Revise to Preliminary/Final Drainage Report for
Riverbend Crossing Filings No. 1 and 2.

**MASTER DEVELOPMENT DRAINAGE
REPORT FOR RIVERBEND CROSSING AND
FINAL DRAINAGE REPORT FOR RIVERBEND
CROSSING FILINGS NO. 1 AND 2**

SEPTEMBER 2018

EXISTING FLOODMAP
EXHIBIT

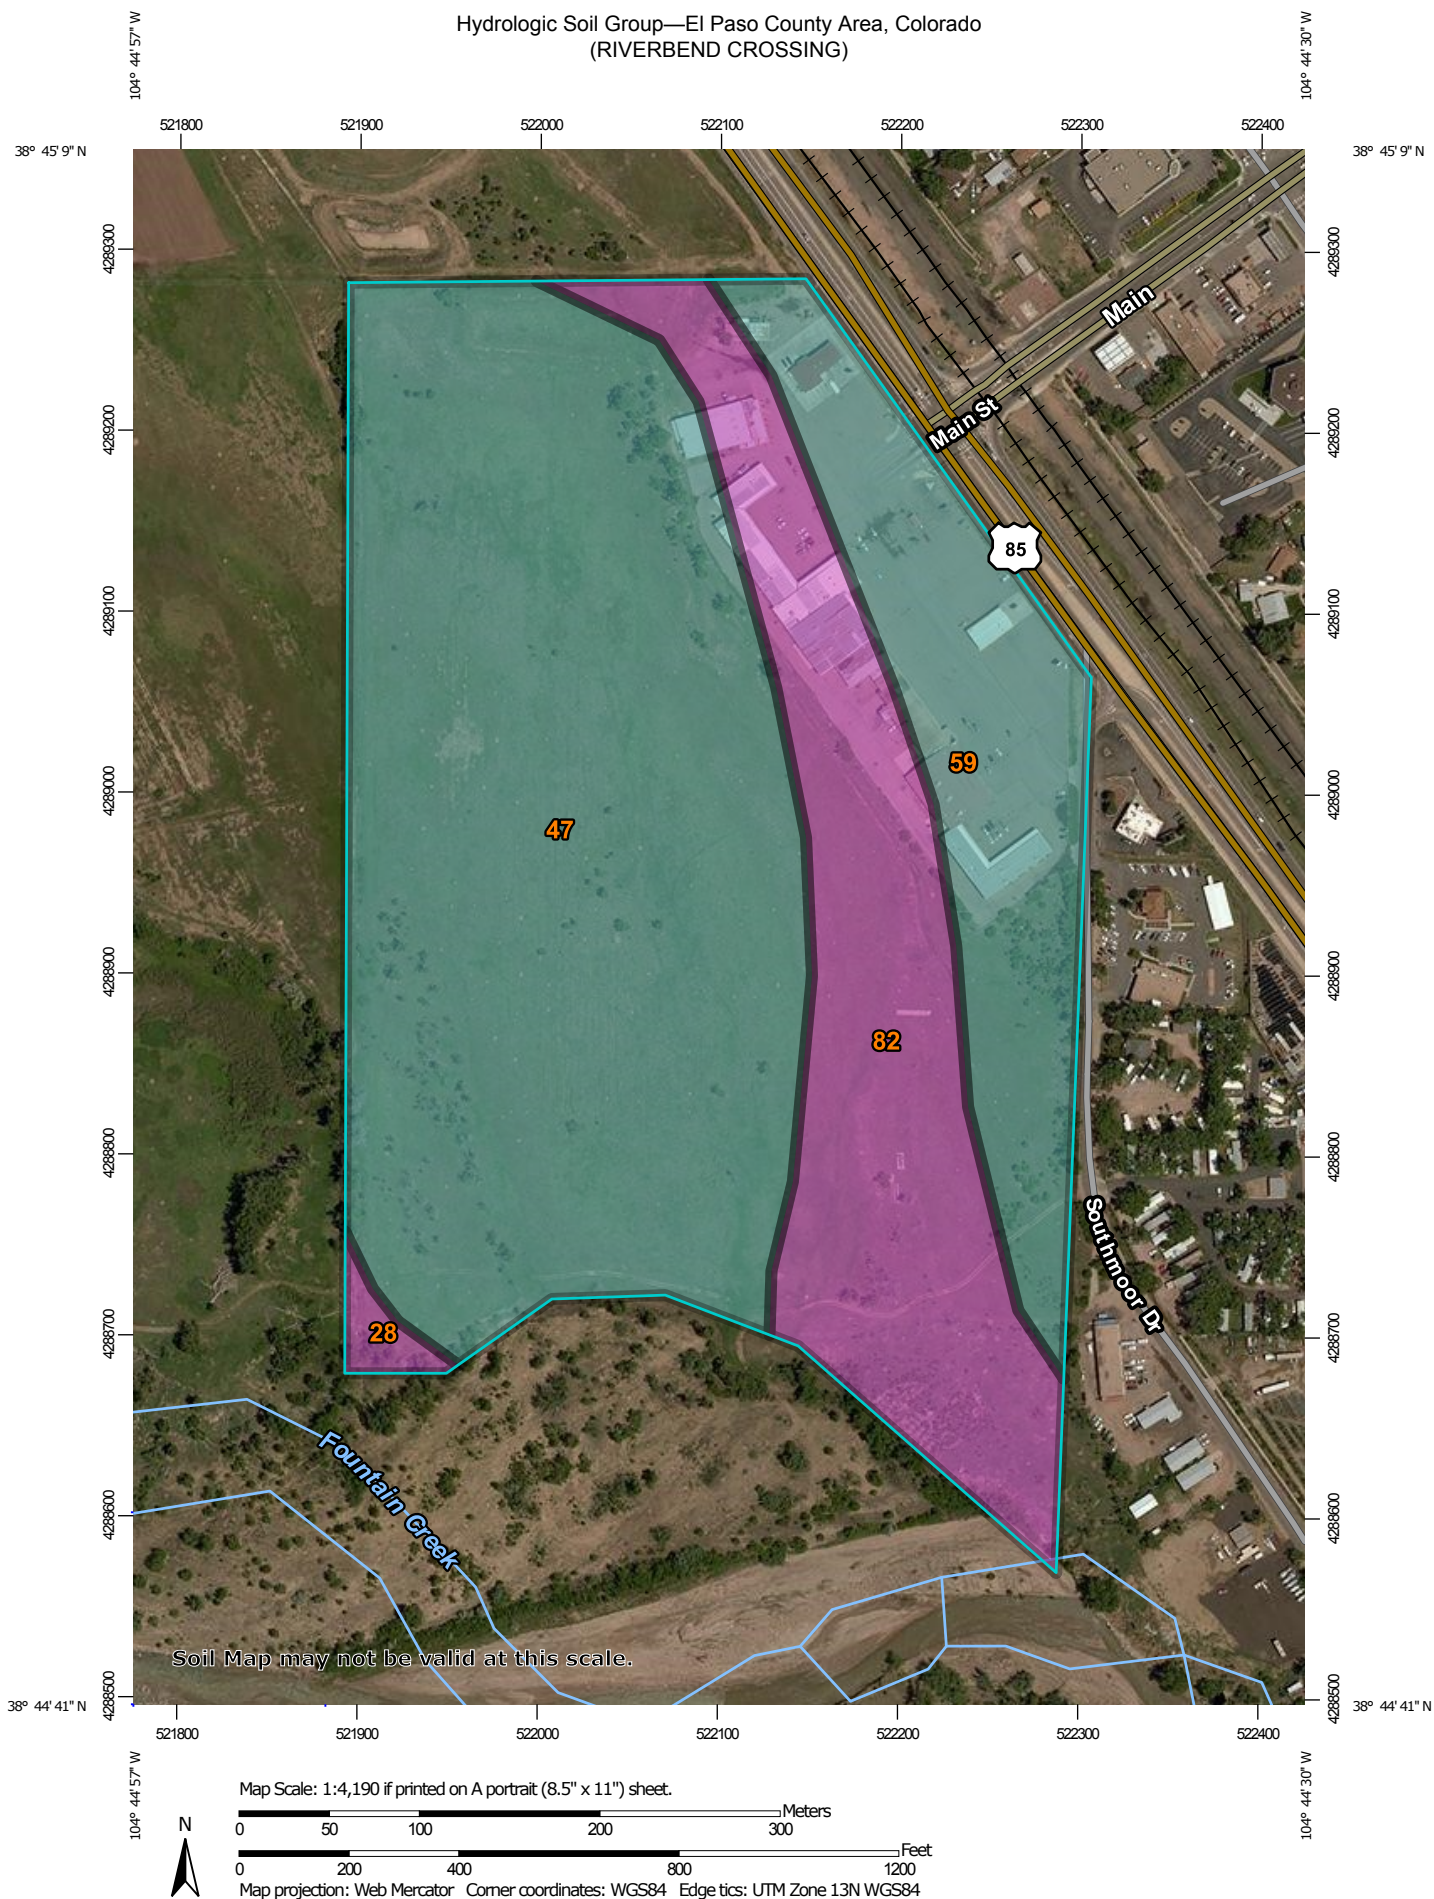
The updated FIRM shows Zone AE (approximately as shown in the highlighted blue area). Verify the topo and floodplain is accurate to contain the floodplain in this area and not just a limits of the design model conducted to generate the floodplain. Field observation does not show any topographical constraint which would create this hard boundary perpendicular to the flow (highlighted in yellow).

A detailed analysis is required regarding the shaded Zone X (100yr flood w/ average depths less than 1 ft). The FIRM appears to indicate that 100yr runoff flows from both Security Creek and Fountain Creek goes through the subdivision. Neither the DBPS nor the Nolte PDR seems to have provided this analysis.

Flood mitigation may be needed by requiring at a minimum the lowest floor be elevated one foot above the 100yr water surface elevation and no basements permitted within the subdivision. Update the plats to include these restrictions if needed.

DETENTION BASIN STAGE-STORAGE TABLE BUILDER

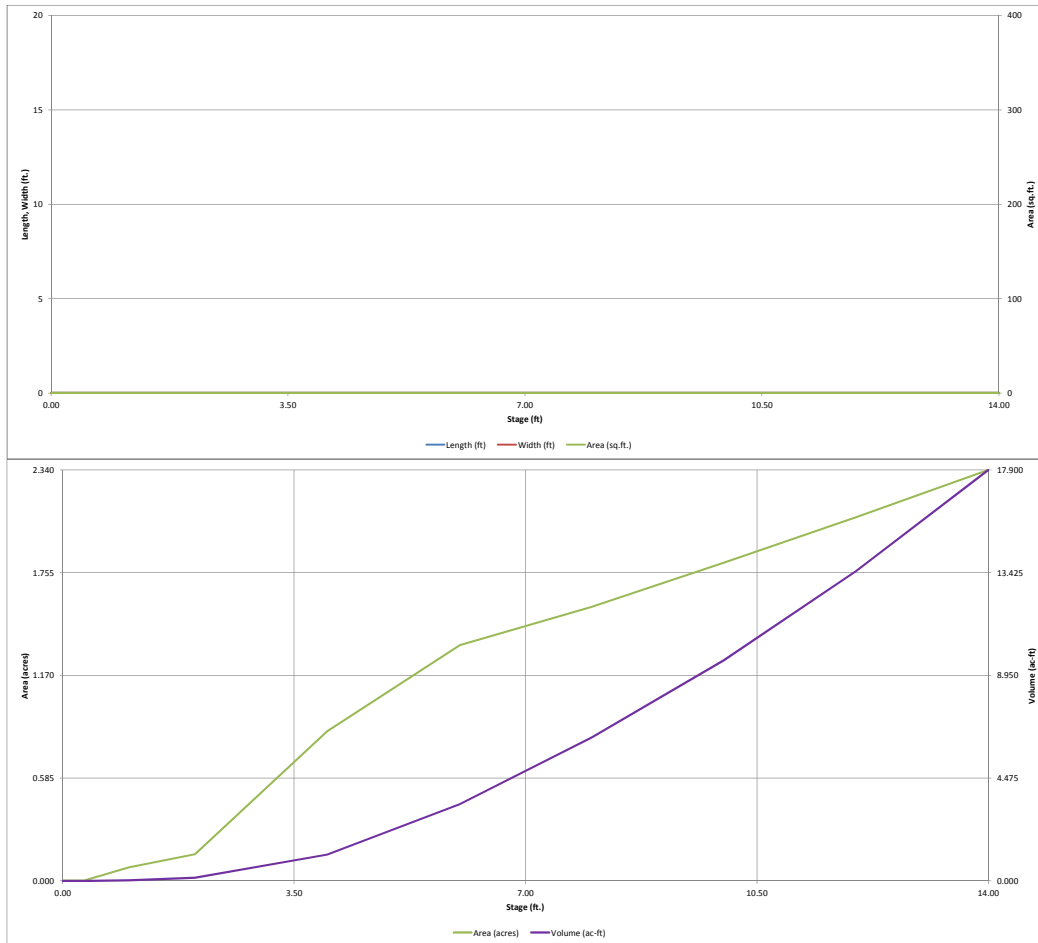
Submit the UD-BMP worksheet
which provides the design calc for
the forebay.

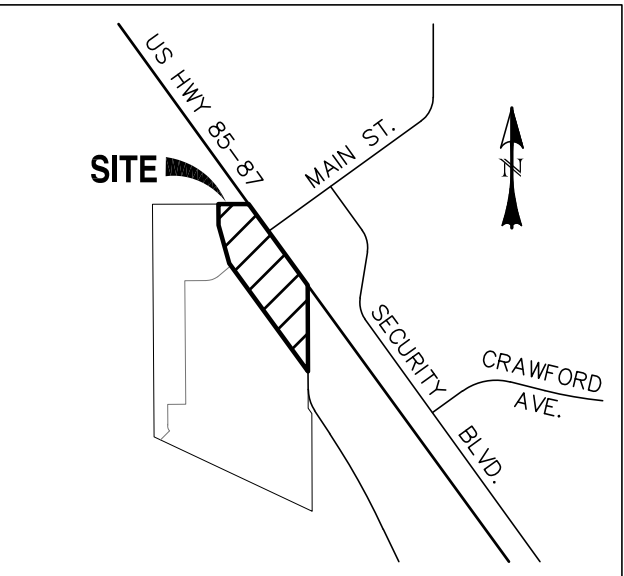
The Nolte PDR identified the need to provide toe/slope protection. The Nolte report noted that the analysis/ HEC-RAS modeling was preliminary in nature. Final hydraulic analysis, design and construction is required.

Both the Nolte PDR and this report's narrative identified the need for a drainage swale along the western boundary. This drainage swale must be located within a tract.

County GIS shows this would drain back into the subdivision at the southwest corner

RIVERBEND CROSSING	
PROPOSED DRAINAGE PLAN

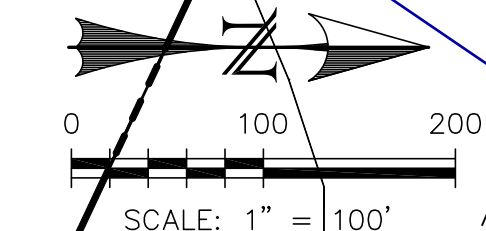
Flows listed for design point 10 do not match the calculations or the narrative. Revise.

1. Make the basin boundary darker for clarity.
2. If applicable, update hydraulic calculations to incorporate the additional 100yr offsite flows from Security Creek and Security Creek going through the shaded zone X.
3. provide contour labels.
4. Include a pond summary table in the proposed drainage map.

Show BFE. The FEMA BFE appears to be from 5691 to 5688. The pond appears to be submerged during the 100yr storm event negating the effectiveness of the detention pond.

Relocate the FSD pond outside the 100yr floodplain. The pond must be above the BFE. If the outlet structure is located below the BFE then tailwater effect must be analyzed.

Revise the contours or place drainage swale in a drainage easement.

Provide maintenance access path from a public street and a ramp to the bottom of pond.

Provide the riprap sizing calculation.

Add on the legend what this symbol represents.

Provide access around the perimeter of the EDB.

Revise Basin B14 boundary. The inlets at the side streets are in a sump condition which continues the cross slope of Booker Blvd down to the inlets. The crosspans will not be able to convey runoff through the intersections. Runoff will turn to the north and into the inlets.

Revise the sub-basin. Based on the contours portions of the commercial development drains into the residential development via Main Street.

The inlet calculation for basin B7 indicates a 10' inlet. Revise accordingly.

The inlet calculation for basin B11 indicates a 15' inlet. Revise accordingly.
